TITLE: WW500
SCH-235000.A01

Company: Acute TechnologyLtd

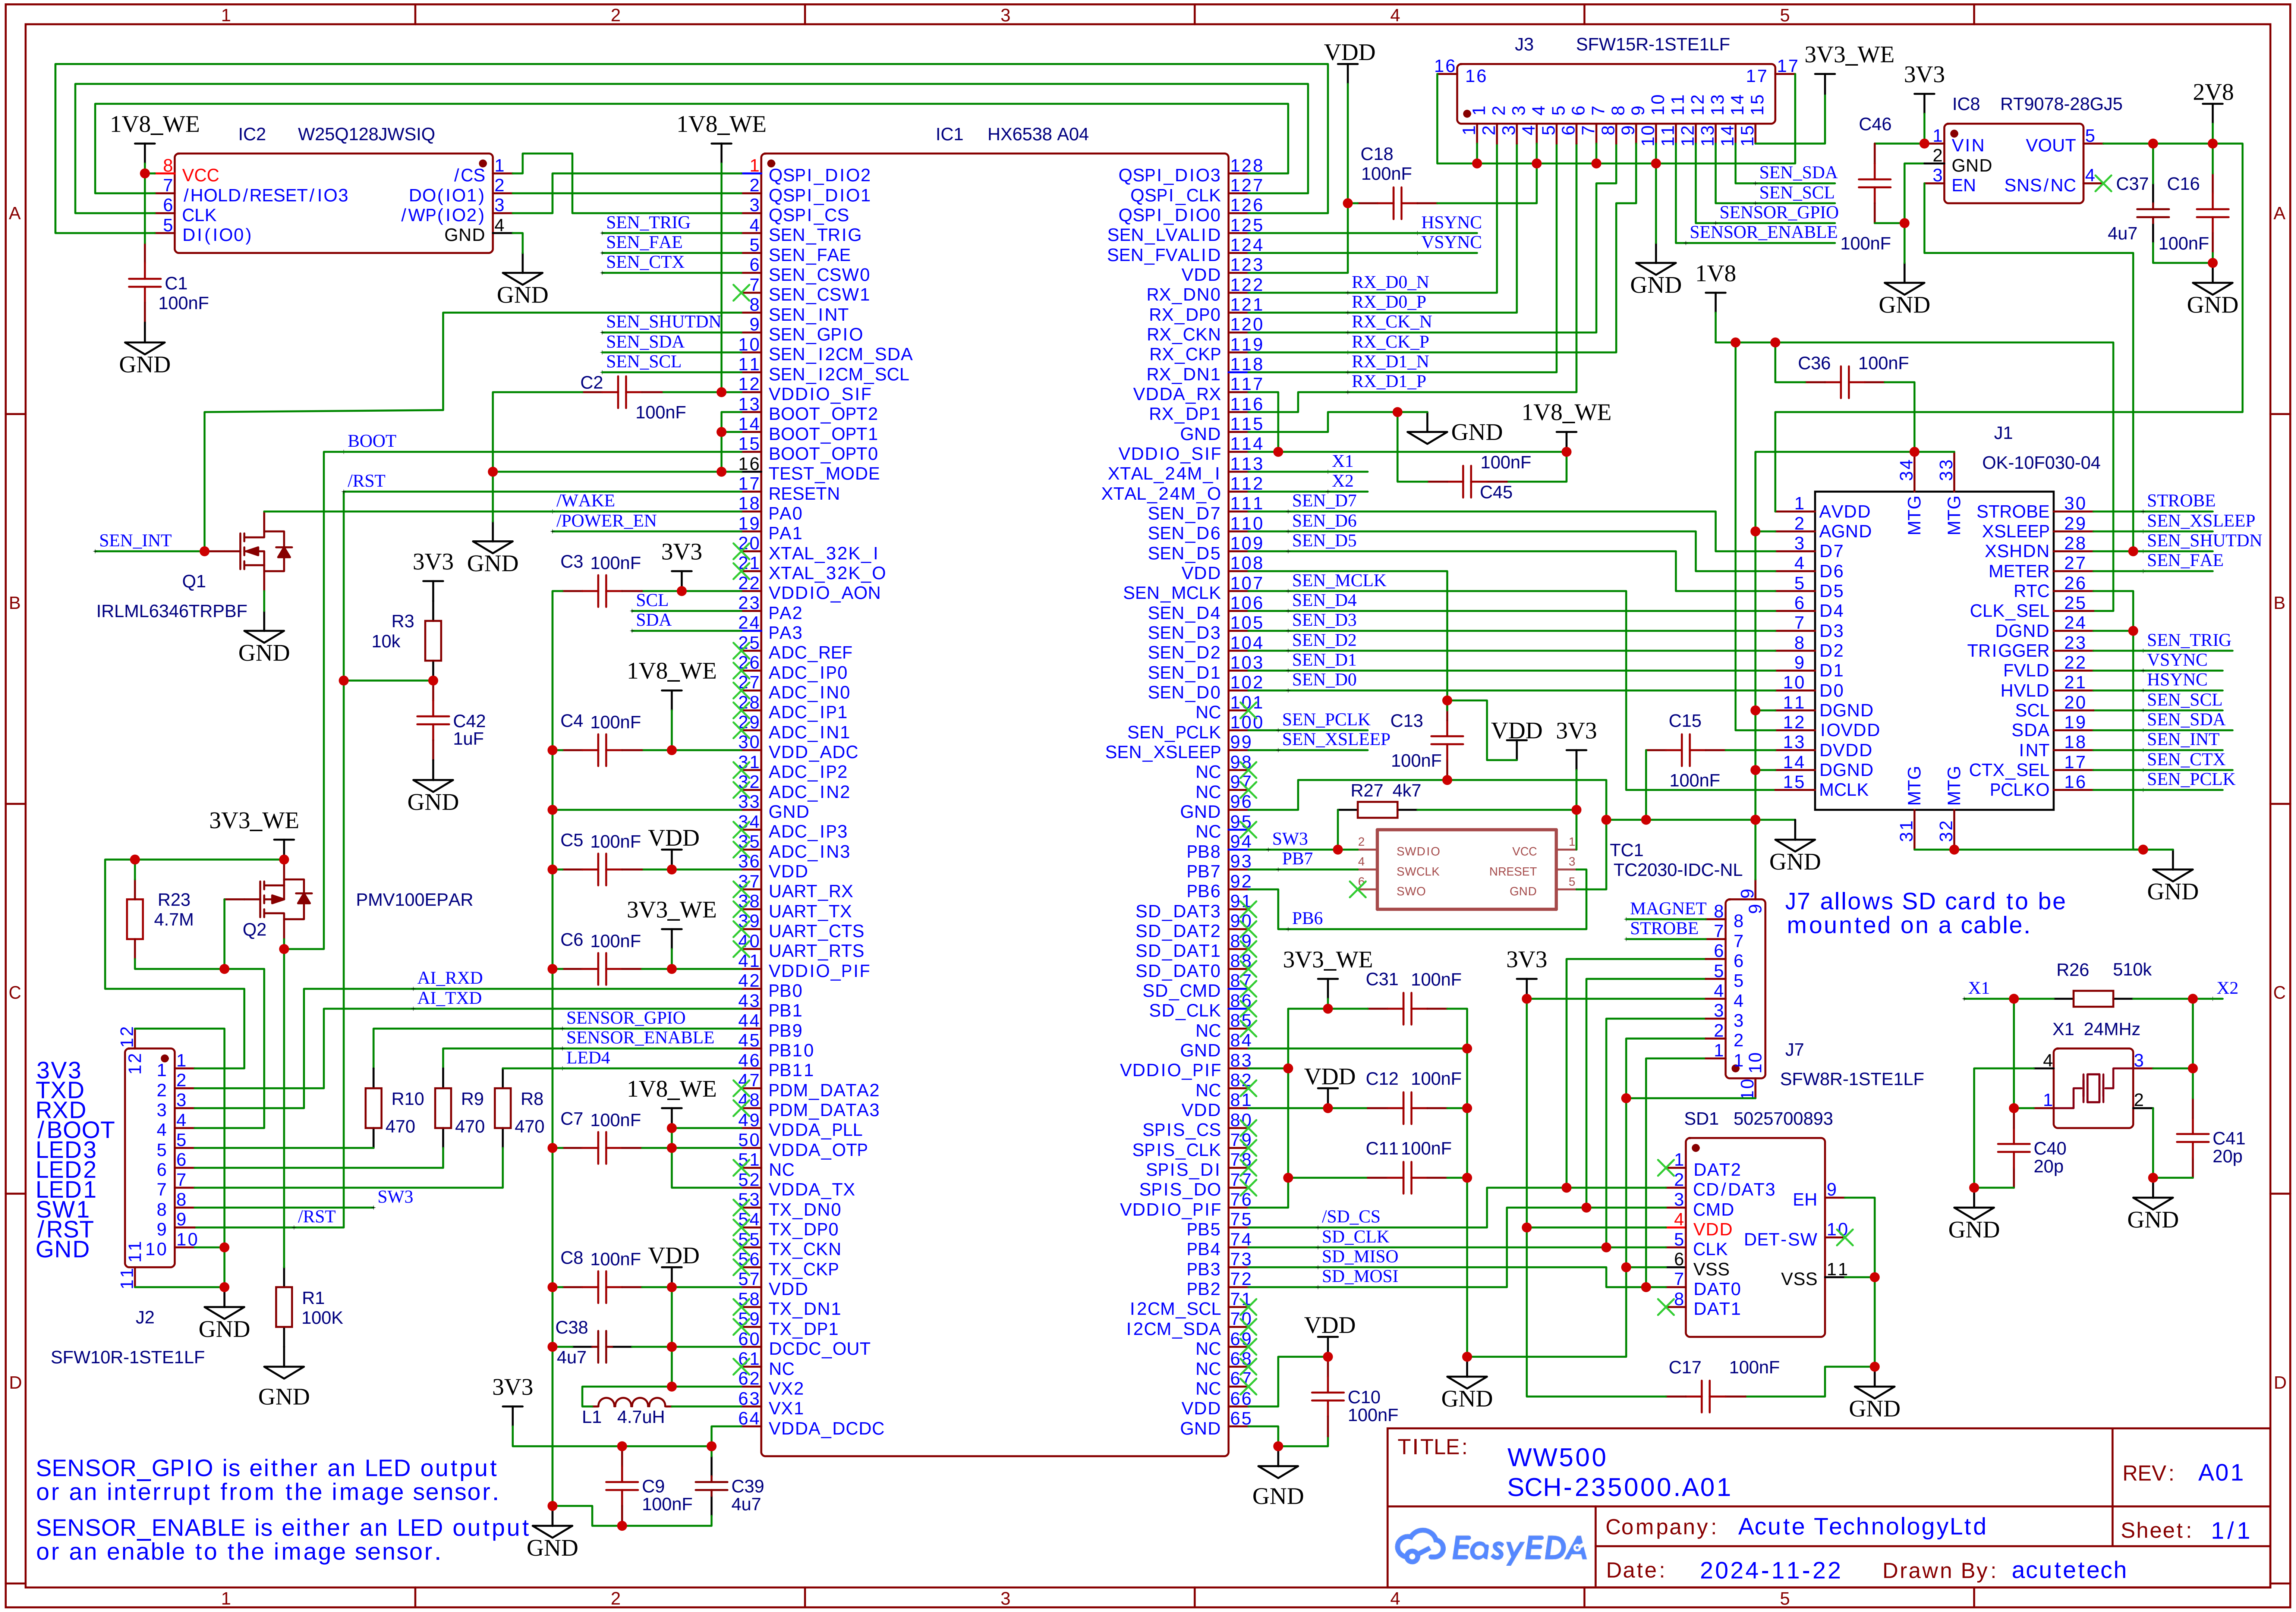
Order Weller bits

Two GPIO pins for IRQ between processors?

TITLE: WW500
SCH-235000.A01
REV: A01
Company: Acute Technology Ltd
Sheet: 2/2
Date: 2024-11-21
Drawn By: acutetech

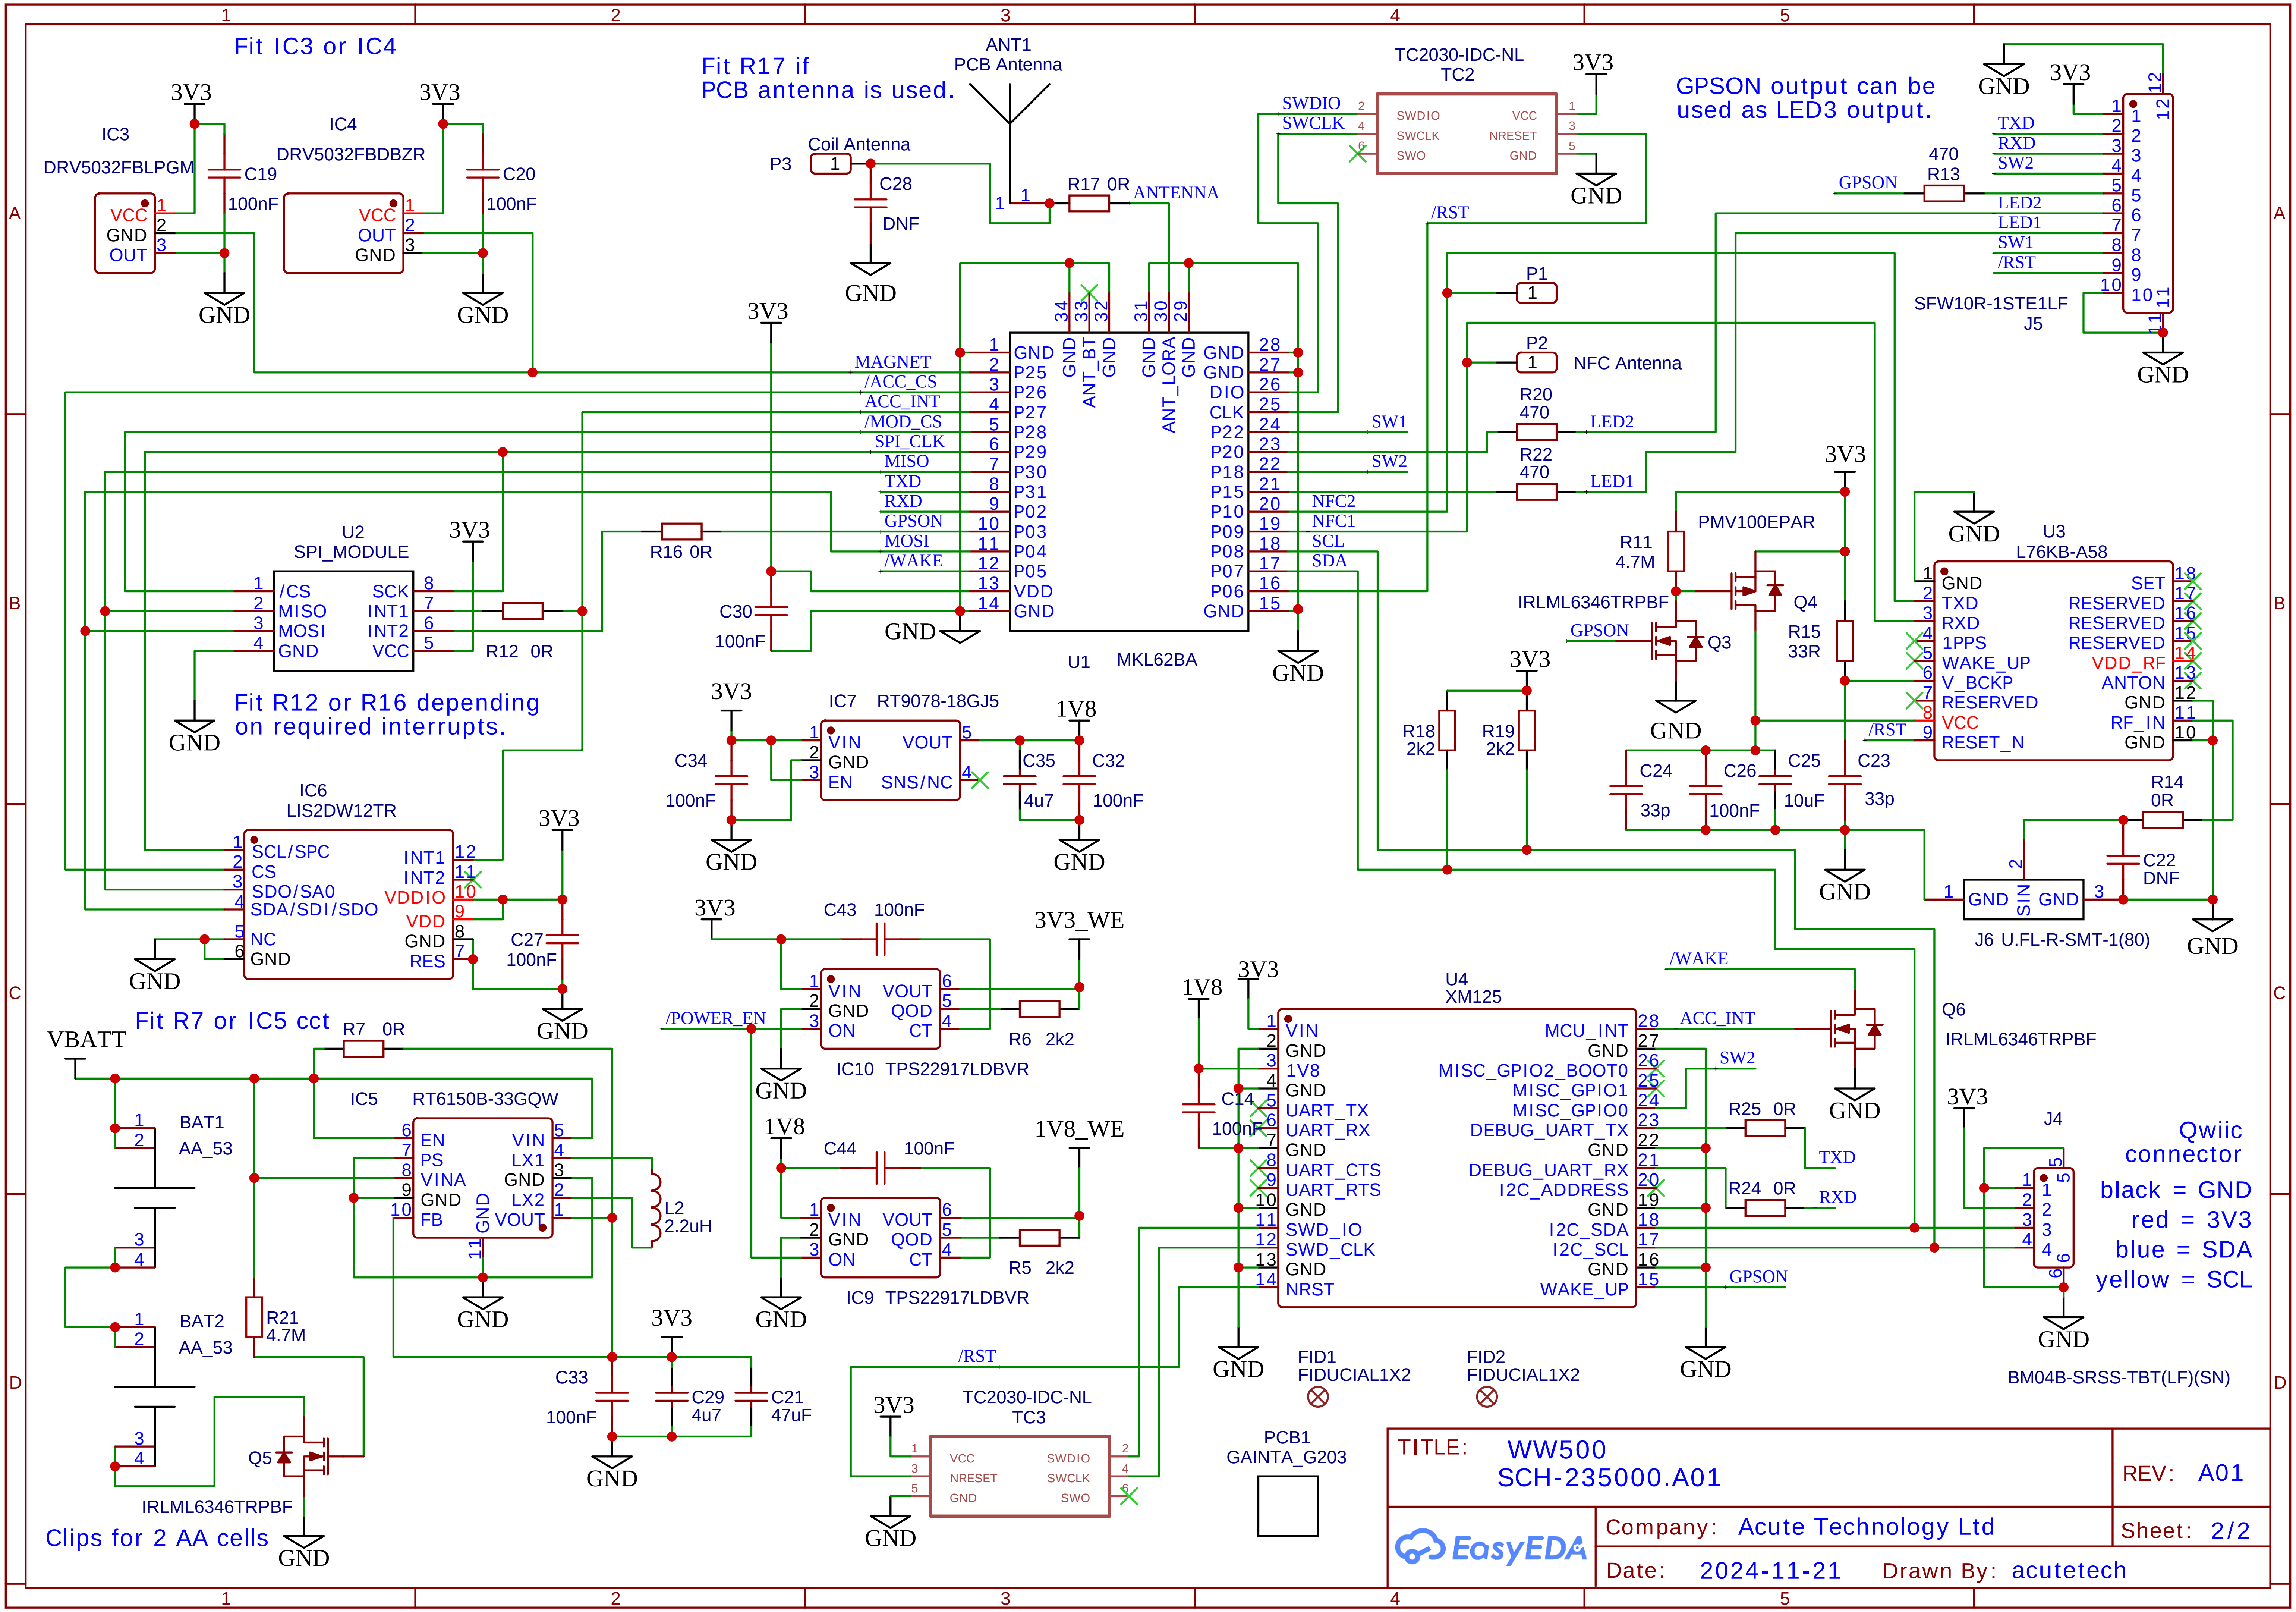
Consider enable on IC5
Also 3V3 or VBAT eslewhere?
